DATE: December 11, 2019

SUBJECT: ADDENDUM #3 TO THE BIDDING DOCUMENTS FOR:  
**BID GROUP #8**  
**MASTER FACILITY PLAN IMPLEMENTATION**  
**COMMUNITY HIGH SCHOOL DISTRICT 99**  
**1436 NORFOLK STREET**  
**DOWNERS GROVE, IL 60516**

This addendum forms a part of the Bidding Contract Documents, dated November 20, 2019. Bidders must acknowledge receipt of this Addendum in the space provided on the Bid Form. Drawing revisions clouded and tagged throughout with delta 39.

# P2.11F

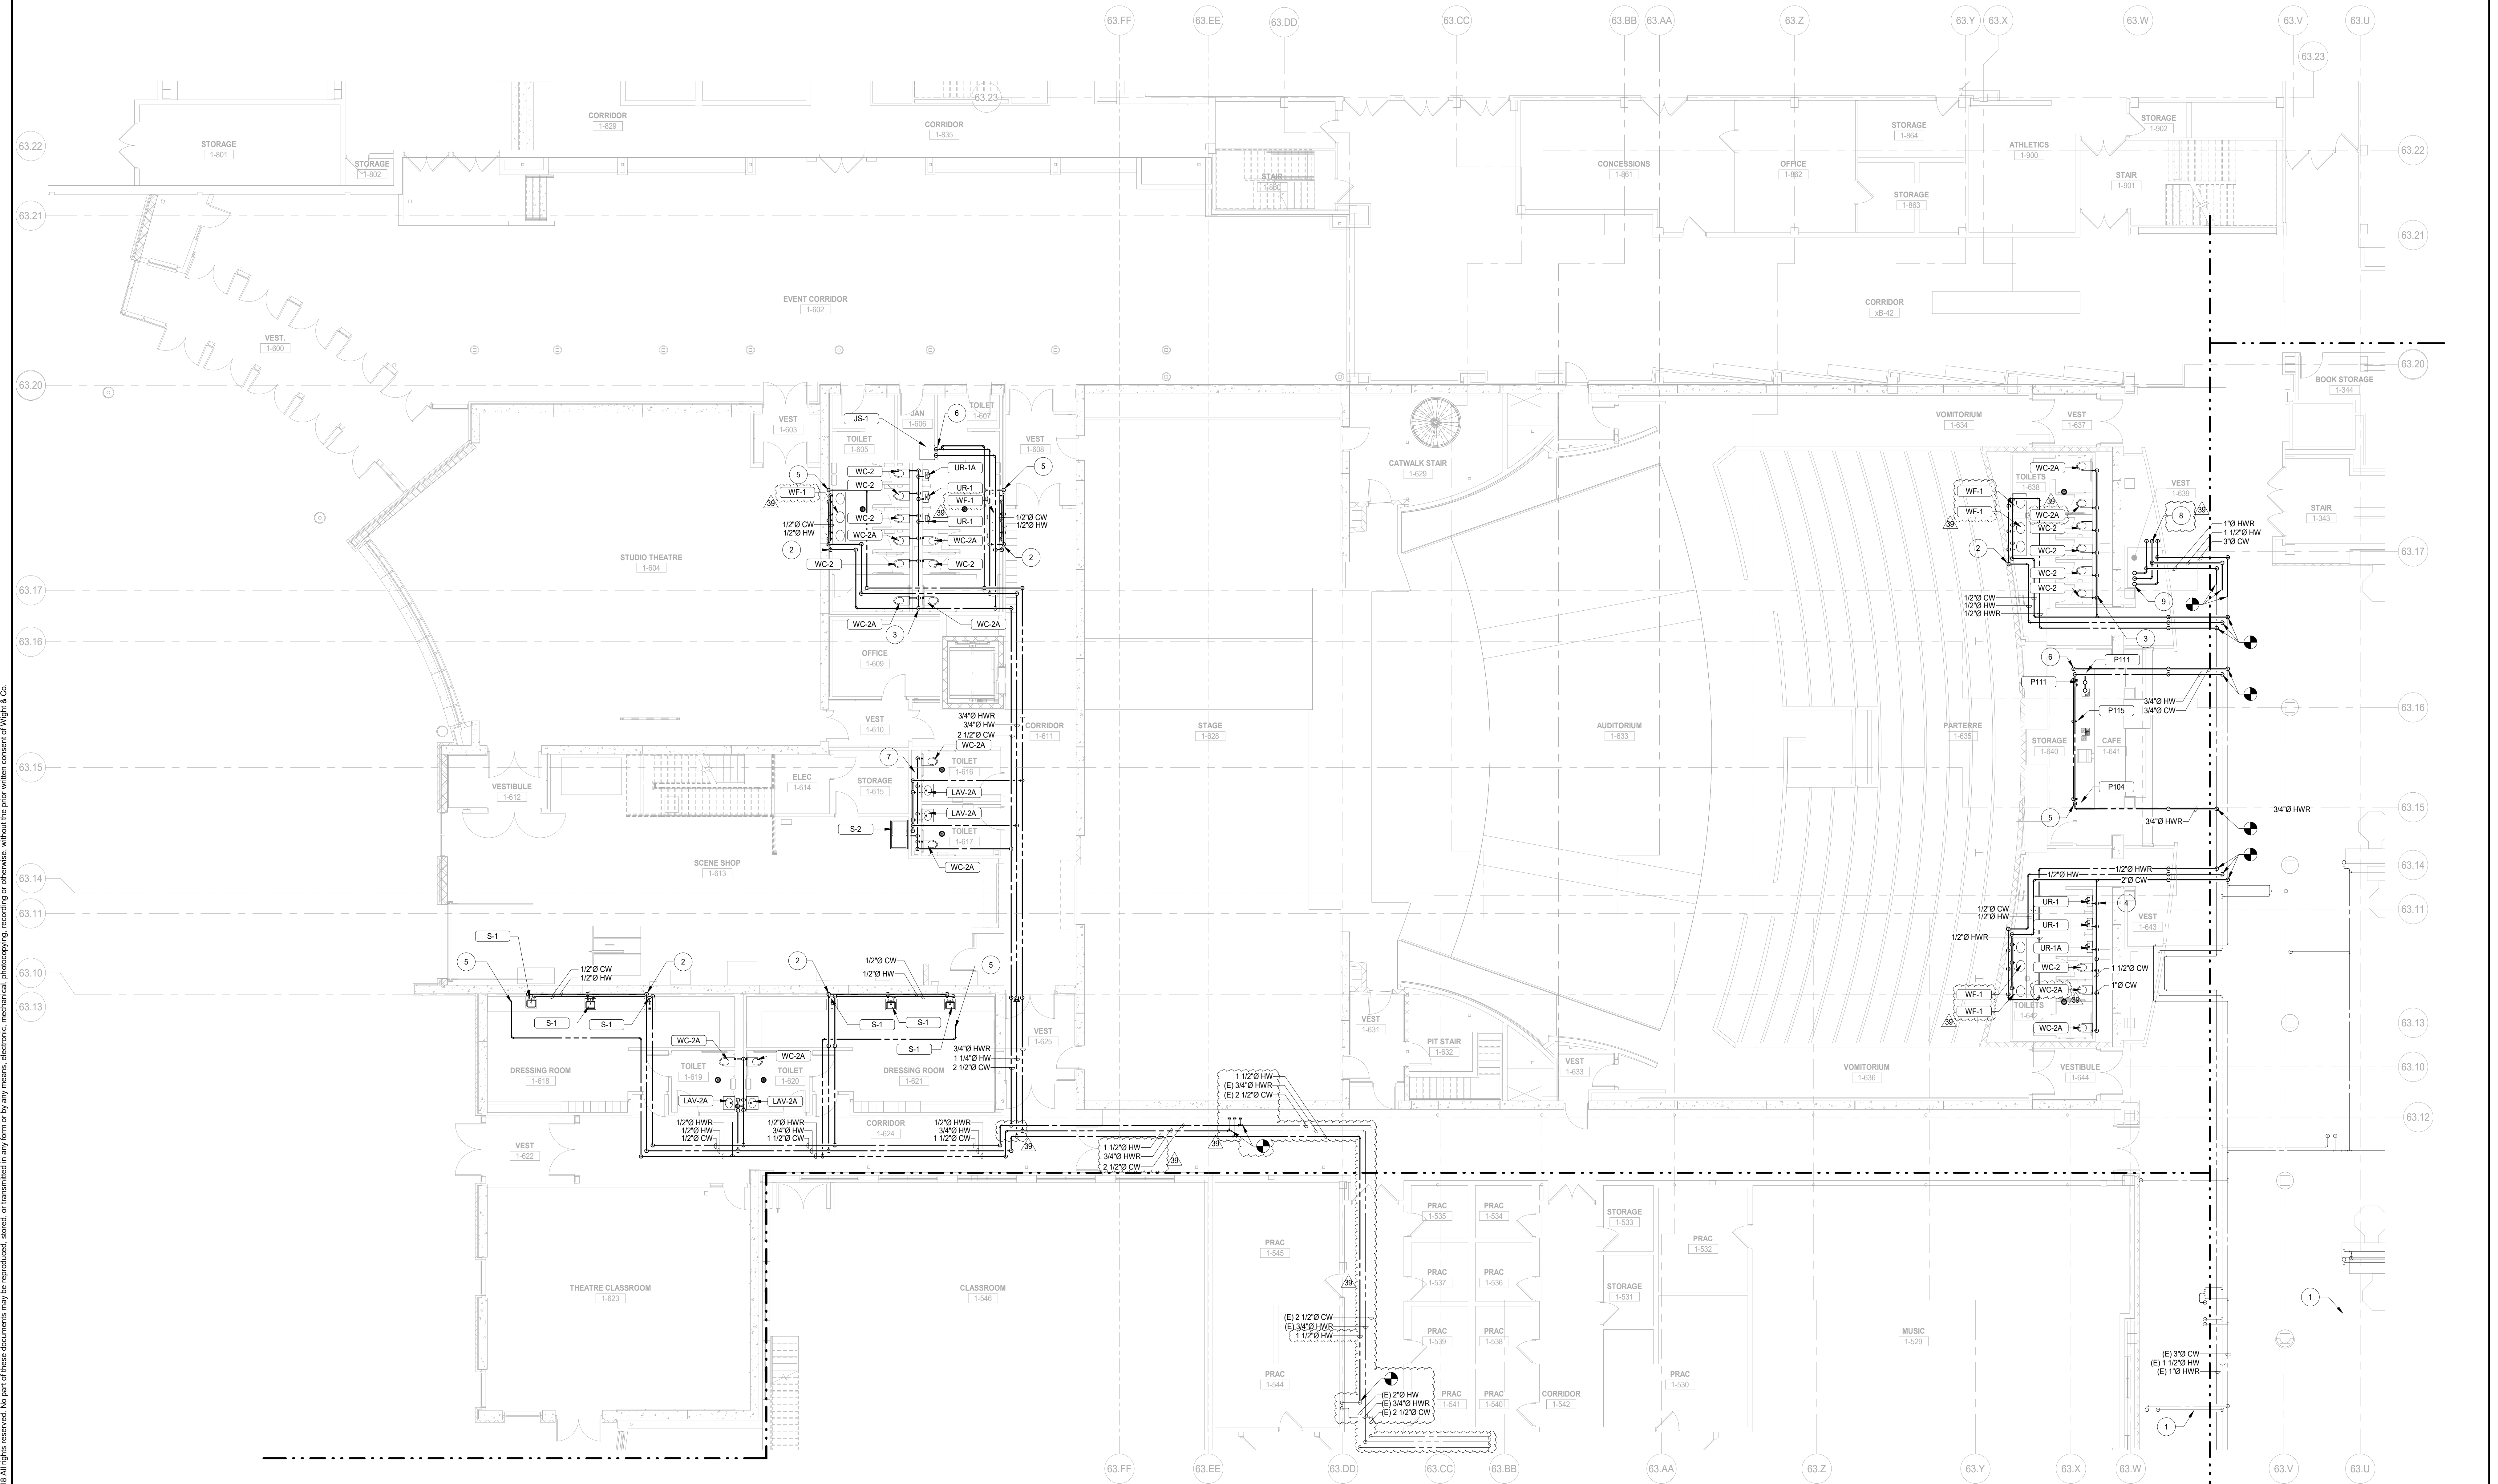
- a. ADD sheet in its entirety.
7. Sheet P2.11F WATER DISTRIBUTION FLOOR PLAN – LEVEL 1 AREA F

1 FIRST FLOOR POWER PLAN AREA D  
SCALE: 1/8" = 1'-0"

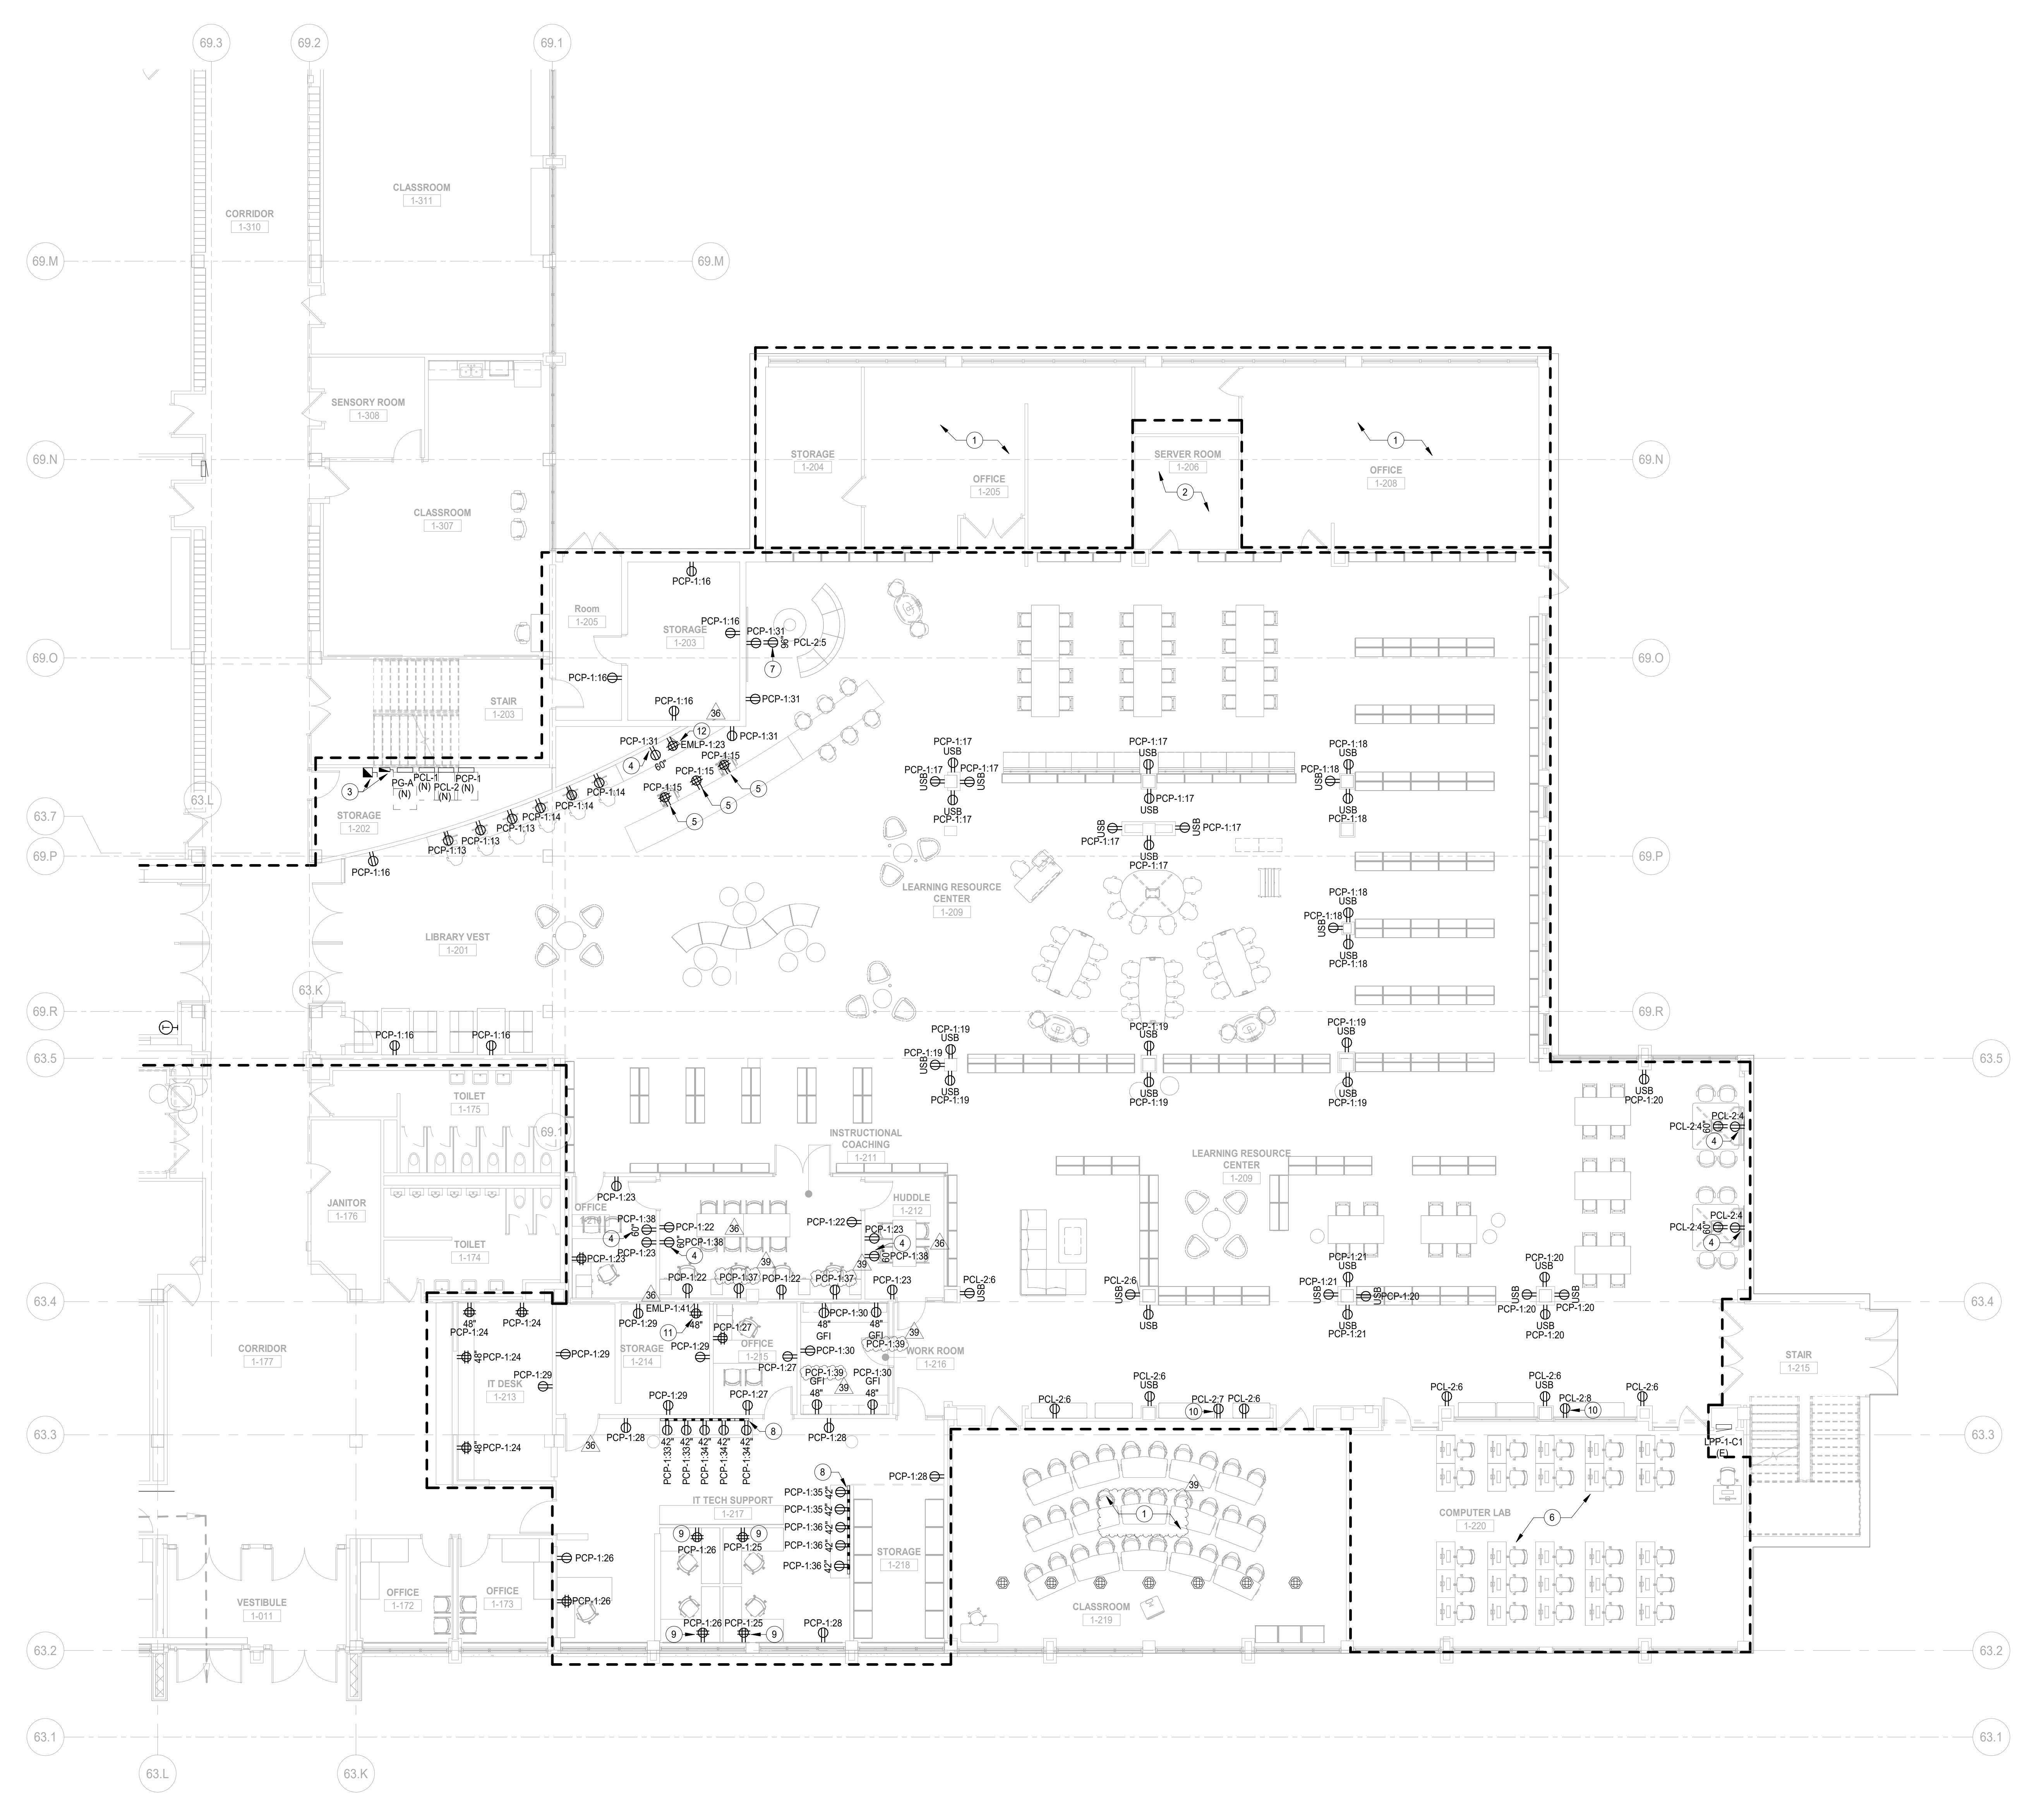
- c. Added keynote #1 to classroom 1-219.
  - d. Added sentence to keynote #2.
  - e. Added sentence to keynote #10.
6. Sheet E2.01E-1c FIRST FLOOR POWER PLAN AREA E (**Full size sheet reissued**)

1 ROOF POWER PLAN AREA F  
SCALE: 1/8" = 1'-0"

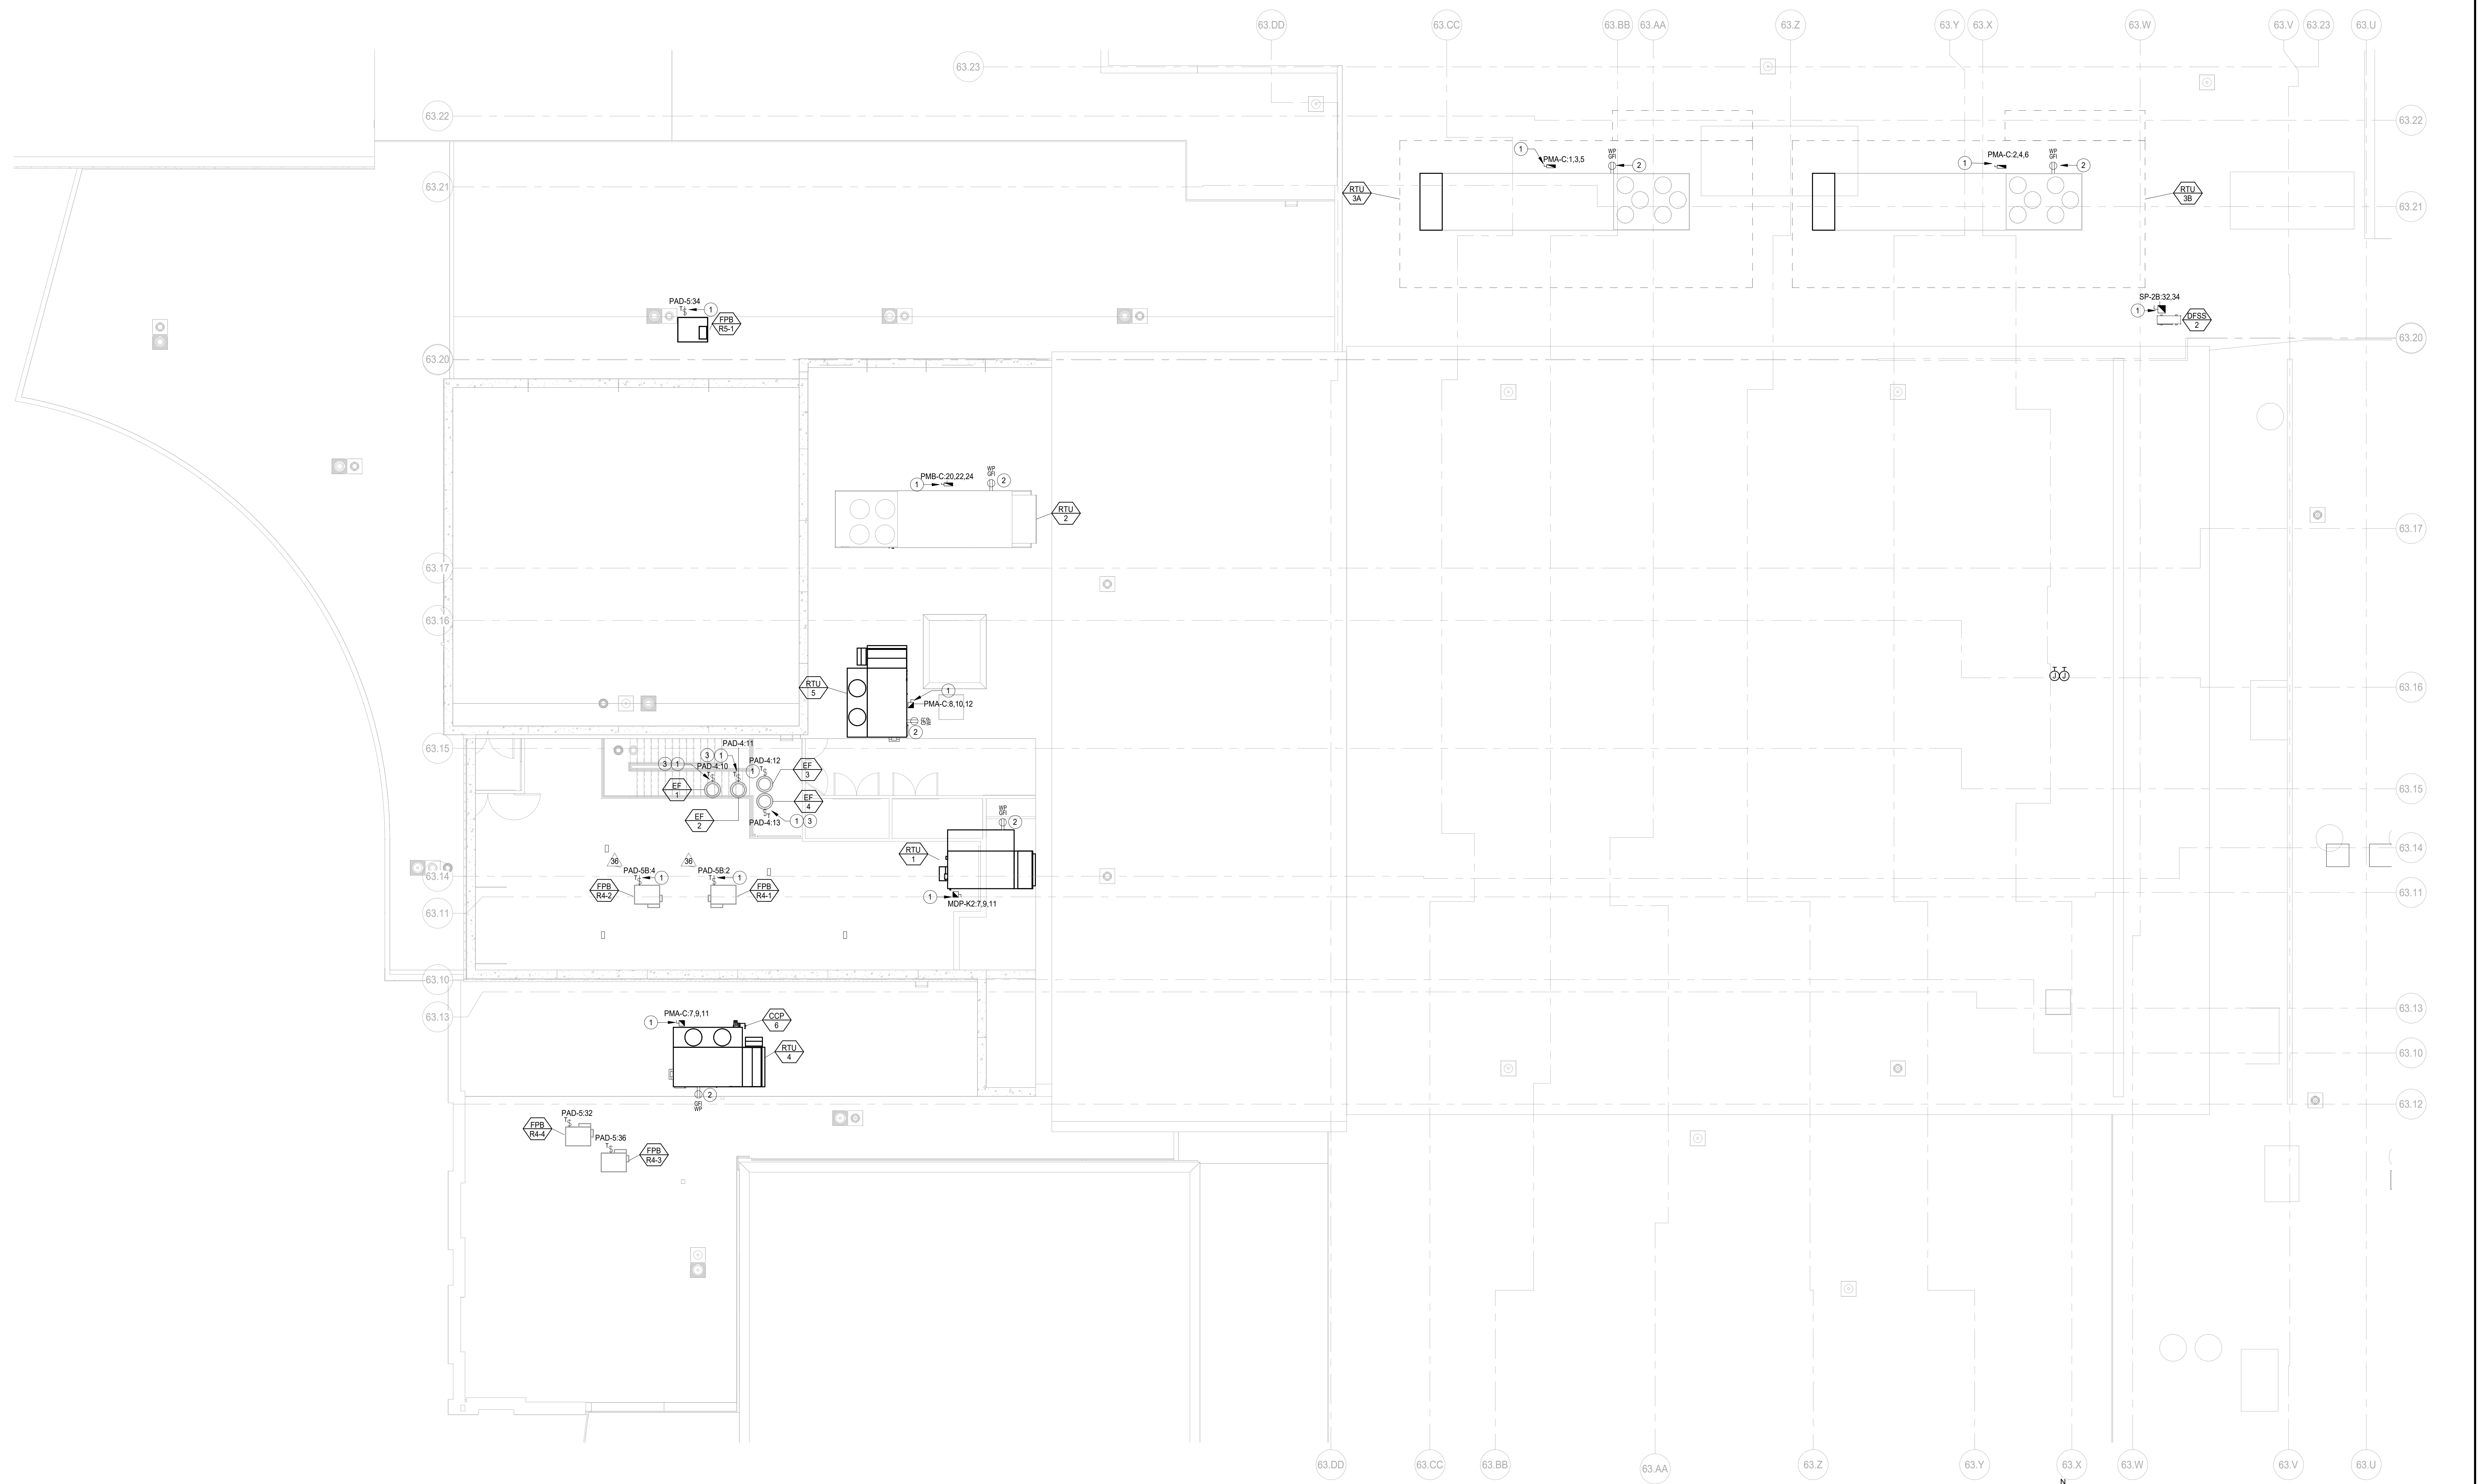
- a. Remove sentence from keynote #2.
12. Sheet E3.00F-1c LOWER LEVEL LIGHTING PLAN AREA F (**Full size sheet reissued**)
- a. Remove all lights, switches, and occupancy sensors from Elev Access 0-721, Orchestra Pit 0-720, and Arbor 0-724. Lighting fixtures connected to theatrical controls. Local control devices to be digital switches as part of theatrical control system. Refer to LD series sheets for lighting design and quantities.
